**PROJECT:** **MOBILE AREA WATER AND SEWER SYSTEM**
**Low Head Pump Building Renovations**

**GMC PROJECT NO. AMOB230011**

**RE:** **ADDENDUM NO. 2 AND ACKNOWLEDGEMENT OF RECEIPT OF ADDENDUM NO. 2**

**ADDENDUM NUMBER 2** **September 29, 2026**

## MODEL WH484
DETAIL SHEET, QUAD

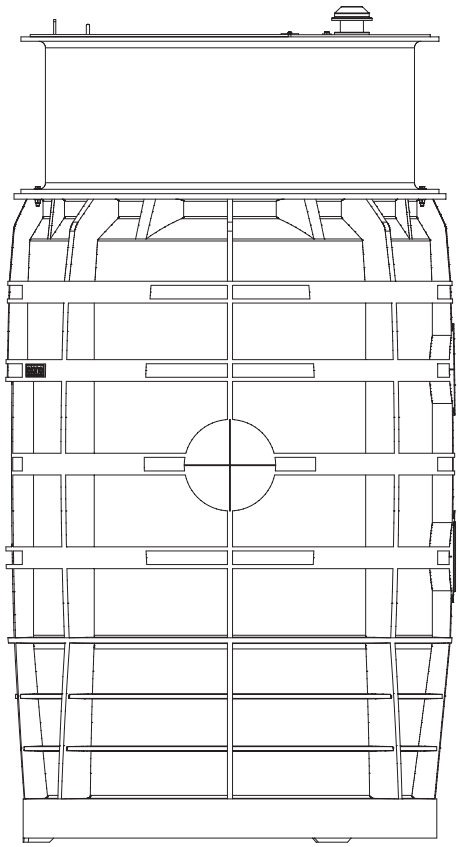
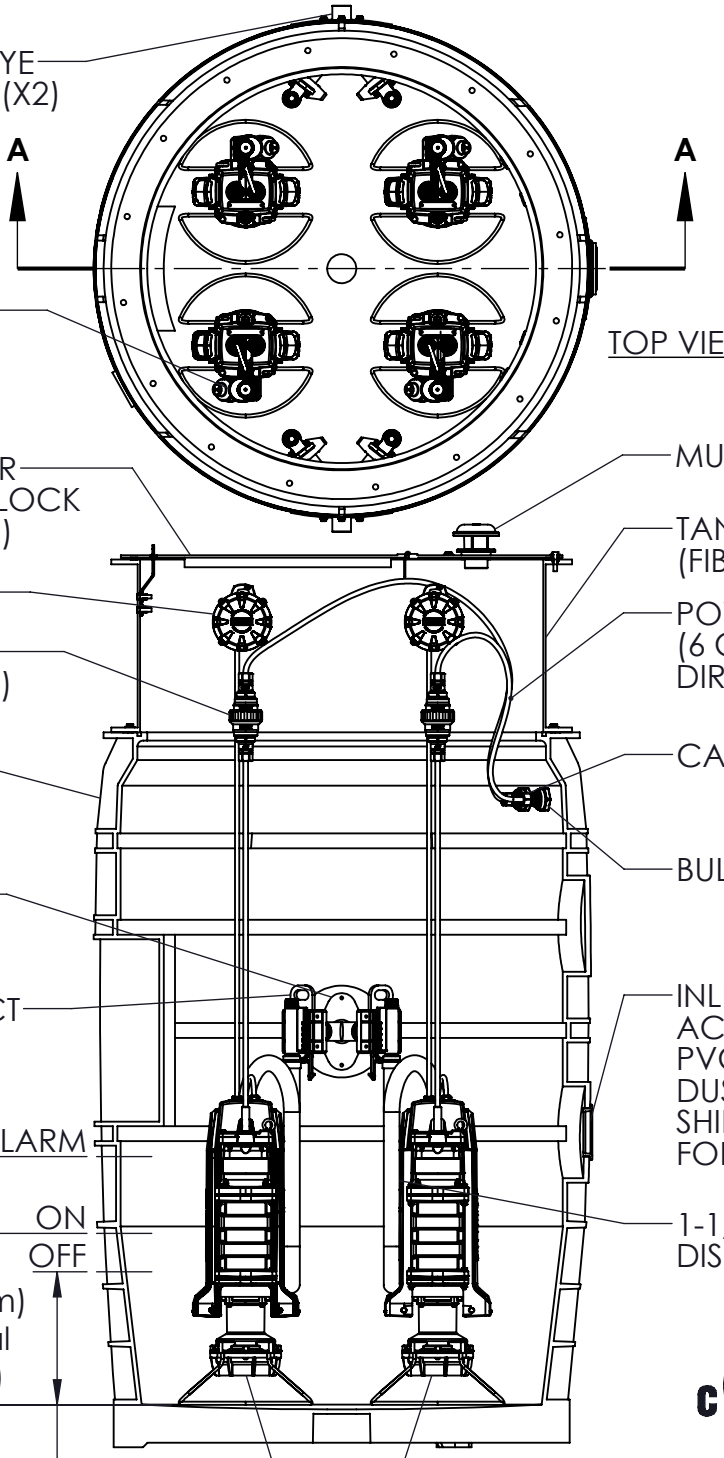
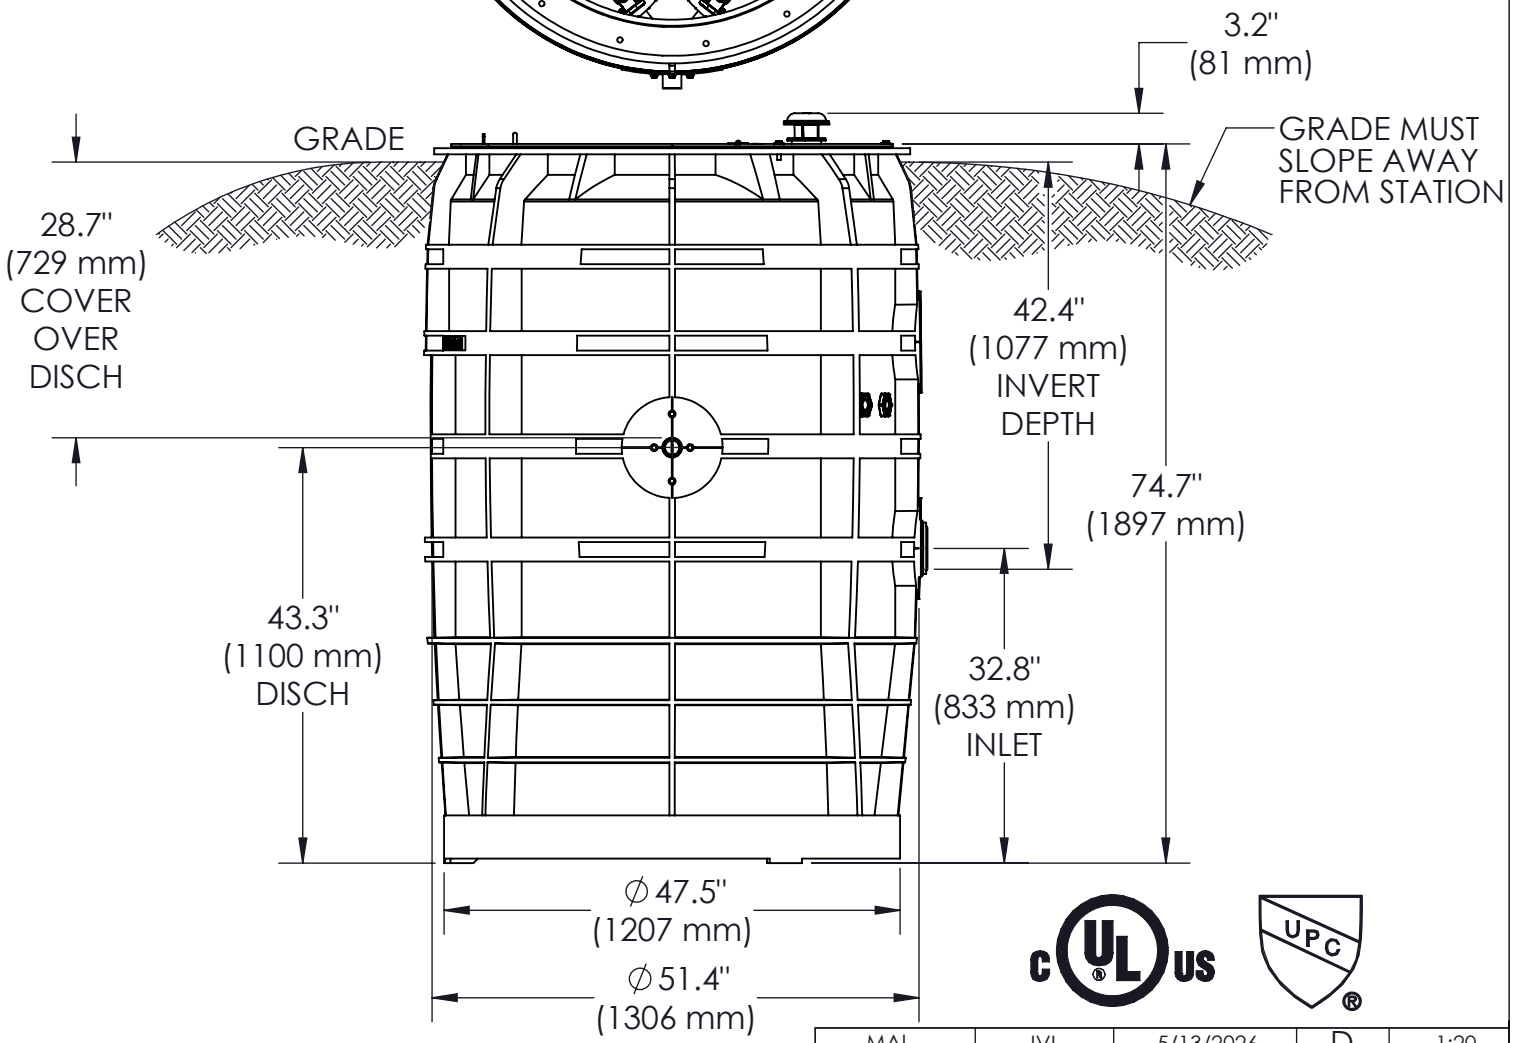
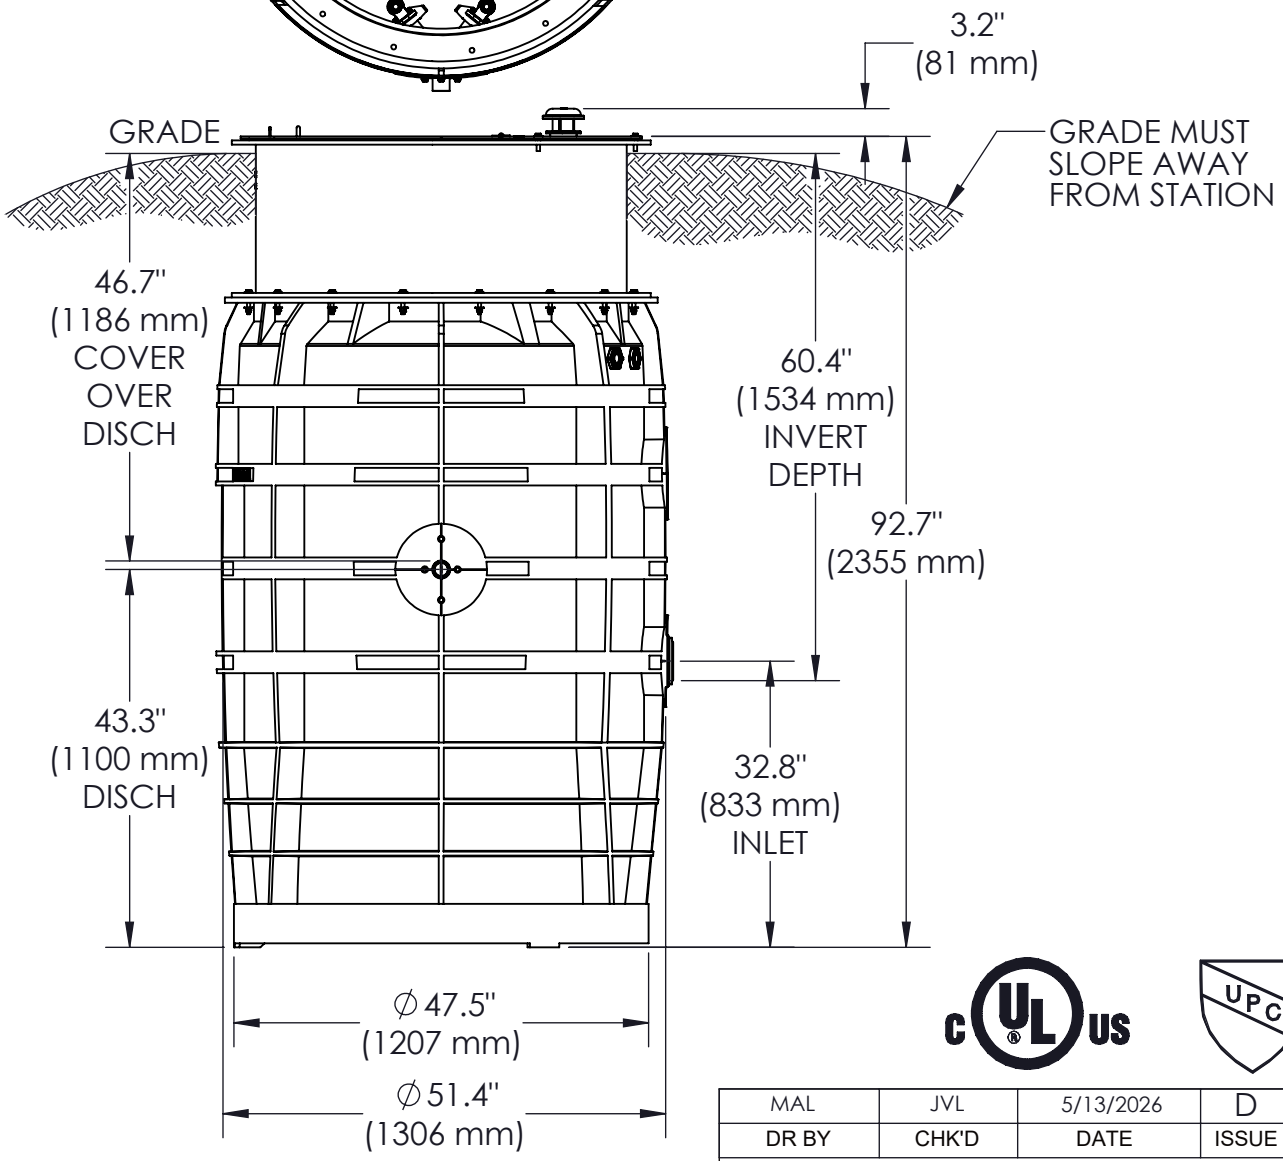
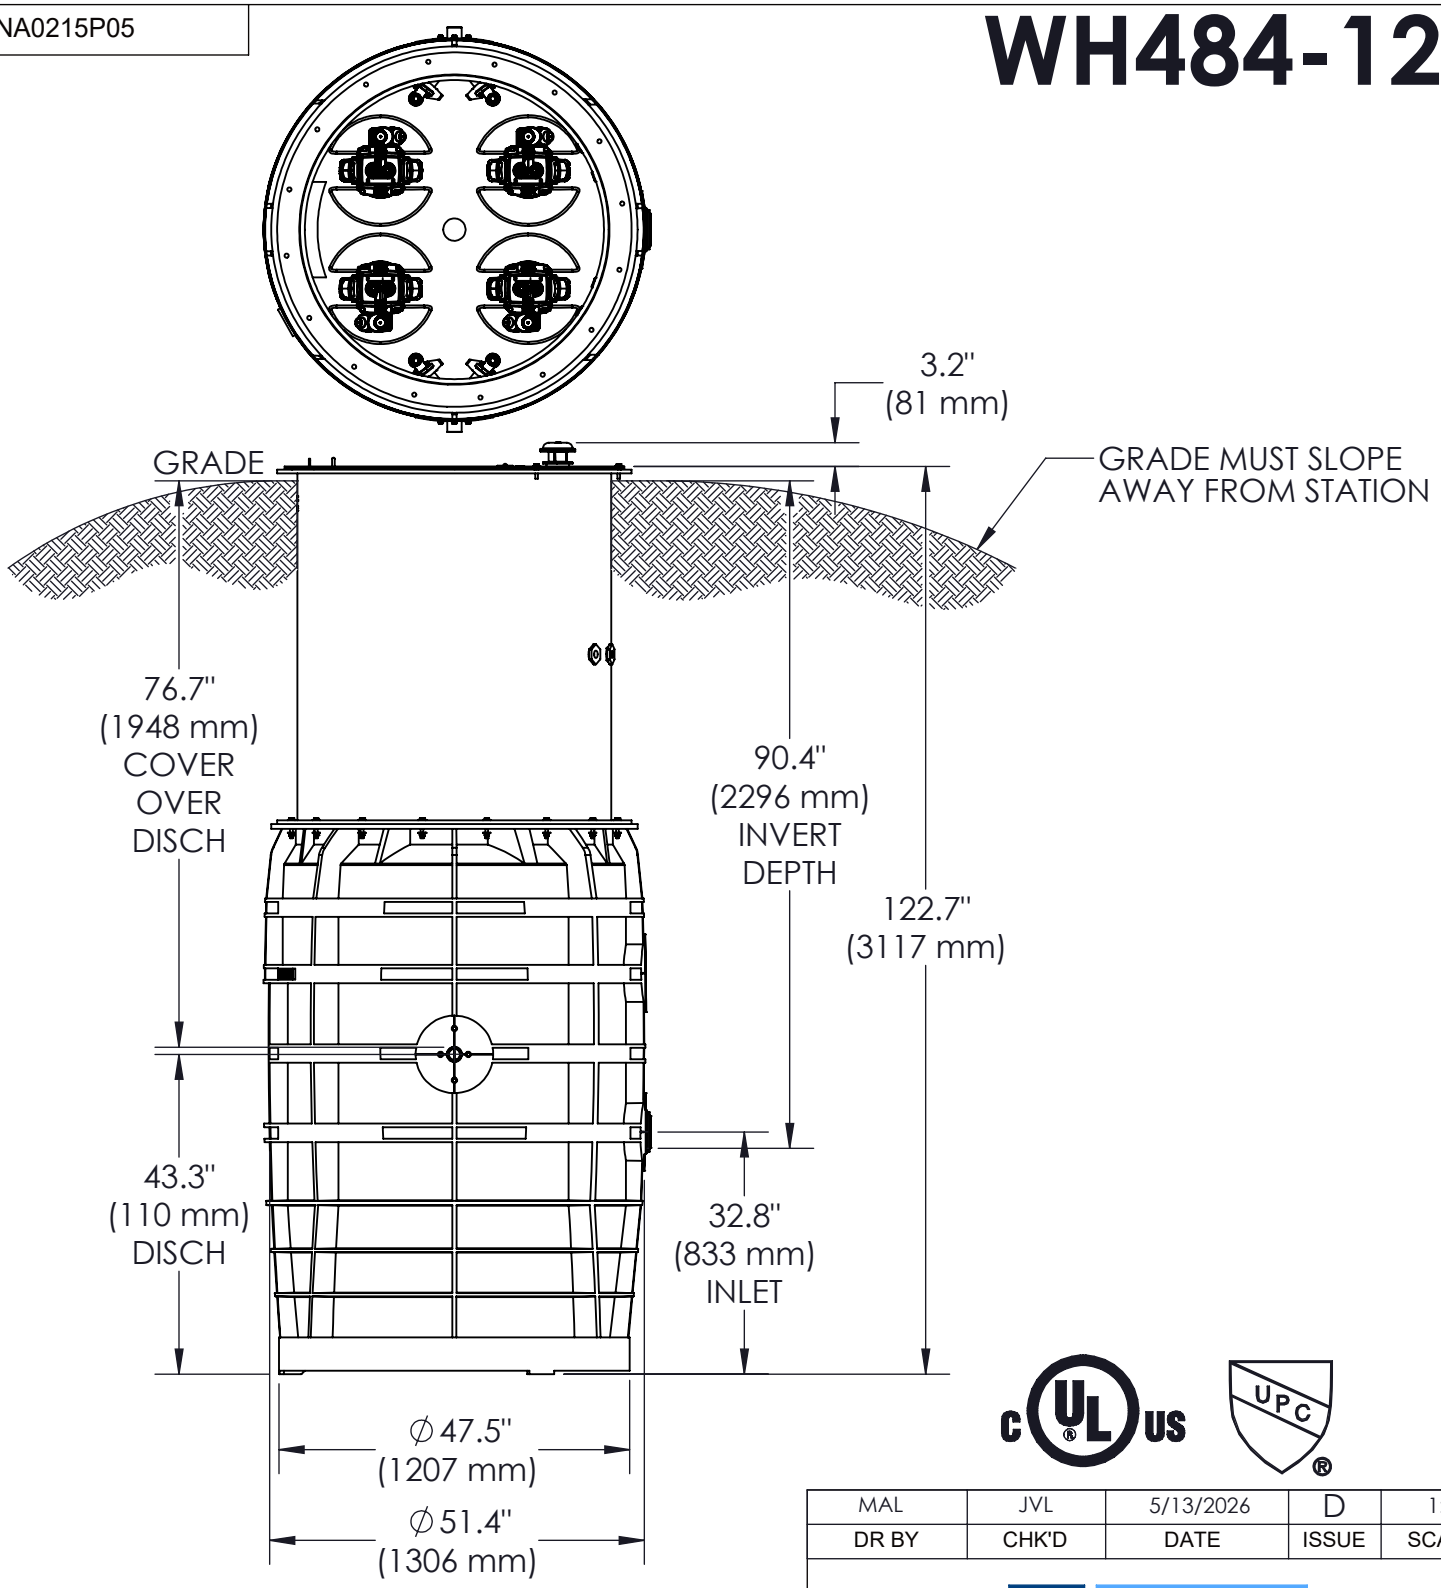
G. See E/ONE Extreme WH484 Quad Pump Cutsheet attached. The attached grinder pump system shall be provided and installed in lieu of the duplex system. Float system shall be delegated design to meet the performance criteria for other float systems on MAWSS' campuses.
